**METROPOLITAN GOVERNMENT OF NASHVILLE AND DAVIDSON COUNTY**

**STAFF RECOMMENDATION**  
**1822 5<sup>th</sup> Avenue North**  
**July 15, 2020**

**Application:** New Construction—Addition and Outbuildings  
**District:** Salemtown Neighborhood Conservation Zoning Overlay  
**Council District:** 19  
**Base Zoning:** R6-A  
**Map and Parcel Number:** 08108027100  
**Applicant:** Jeff Zeitlin, Developer  
**Project Lead:** Sean Alexander, sean.alexander@nashville.gov

<p><b>Description of Project:</b> This application is for a rear addition and two carports at the rear of the lot.</p> <p><b>Recommendation Summary:</b> Staff recommends approval of the proposed addition and outbuildings, with the following conditions:</p> <ol style="list-style-type: none"> <li>1. The window and door selections shall be approved prior to purchase and installation; and</li> <li>2. The HVAC Units shall be located beyond the midpoint of the building, or at the rear</li> </ol> <p>With these conditions, staff finds that the application meets the design guidelines for New Construction in the Salemtown Neighborhood Conservation Zoning Overlay.</p>	<p><b>Attachments</b>  <b>A:</b> Photographs  <b>B:</b> Site

SITE PLAN

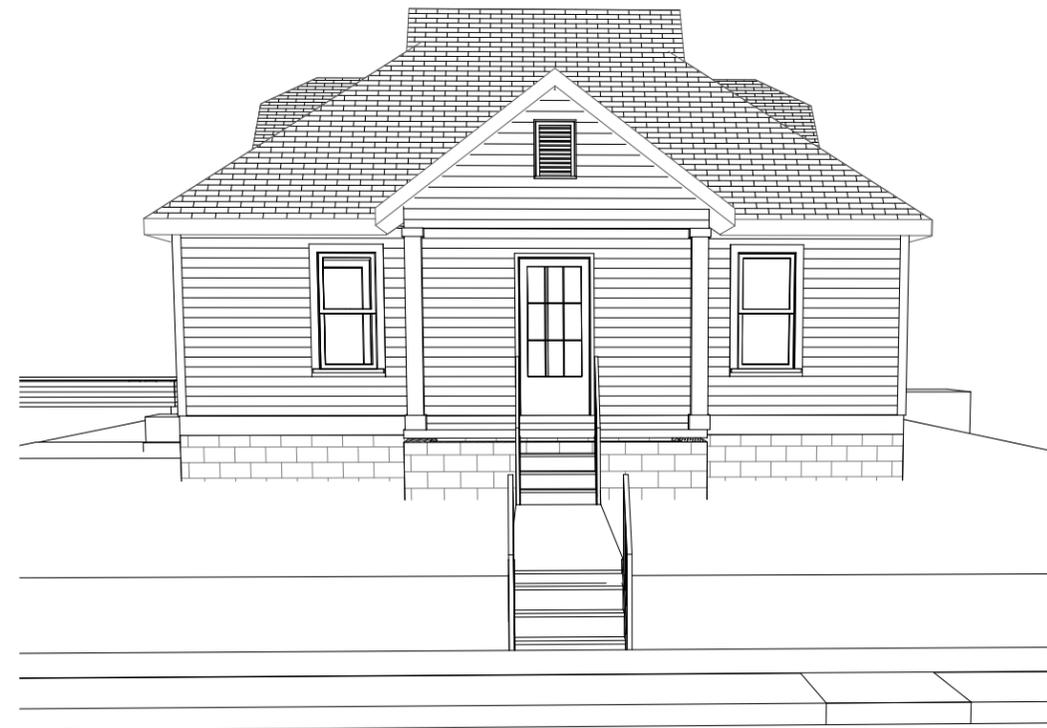
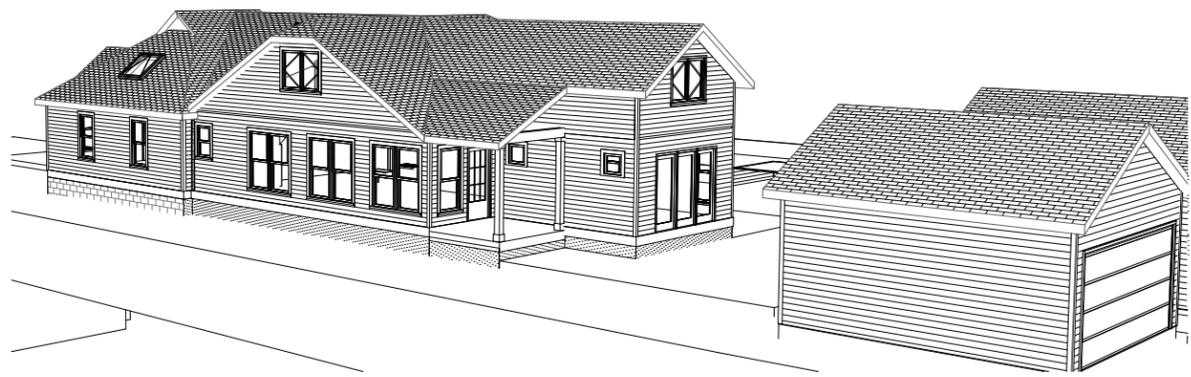
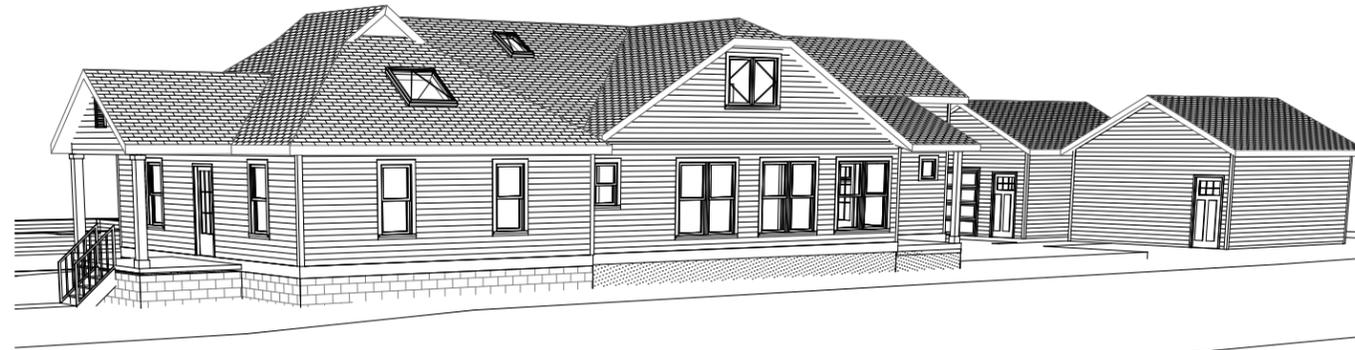
Setback & Rhythm of Spacing: With the addition stepped in from the sides of the house, the new construction meets the standard five foot (5’) setbacks from the side property lines, and the addition will not disrupt the perceived rhythm of spacing between adjacent buildings.

Staff finds that the project meets section III.C of the design guidelines.

GARAGES

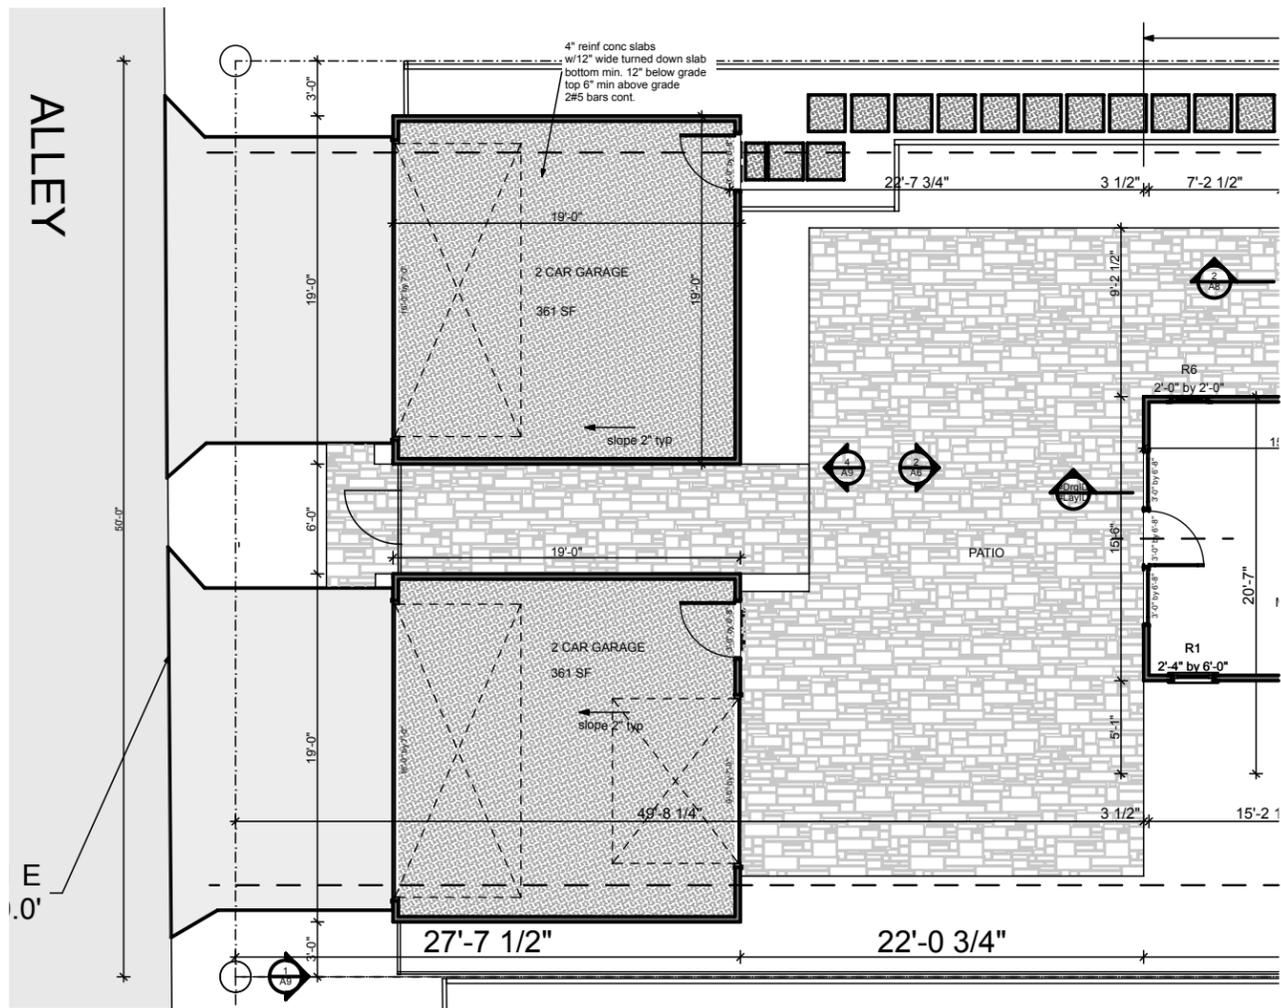
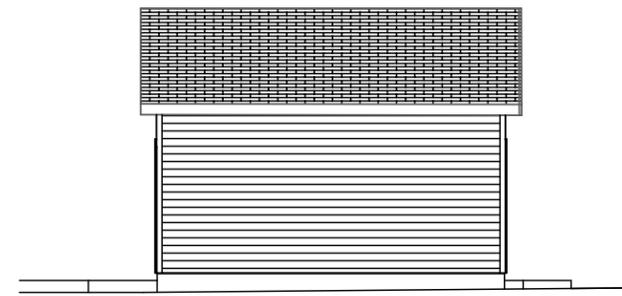
Outbuildings: Two new outbuildings are proposed to be built at the rear of the lot.

*Design Standards:* The outbuildings have a simple, utilitarian design that is appropriate for outbuildings. The outbuilding’s forms, detailing, and roofs do not contrast with the primary structure and will be appropriately located at the rear of the lot.

These roof the forms and pitches are similar to historic outbuildings, therefore Staff finds that the project meets Sections III.H.1 and III.H.3 of the design guidelines.

With the staff’s final approval of the door selections, staff finds that the known materials meet sections III.H.4 and III.H.5 of the design guidelines.

<b>MINIMUM</b>	<b>PROPOSED</b>
<b>Space between principal building and DADU/Garage</b>	20'	22'
<b>Rear setback</b>	5'	10'
<b>L side setback**</b>	5'	3'
<b>R side setback**</b>	5'	3'
<b>How is the building accessed?</b>	From the alley	Yes

Staff finds that the location of the proposed outbuilding is compatible with the location of outbuildings historically and that it meets the setback and site planning requirements of section III.H of the design guidelines.

3. The window and door selections shall be approved prior to purchase and installation; and
4. The HVAC Units shall be located beyond the midpoint of the building, or at the rear
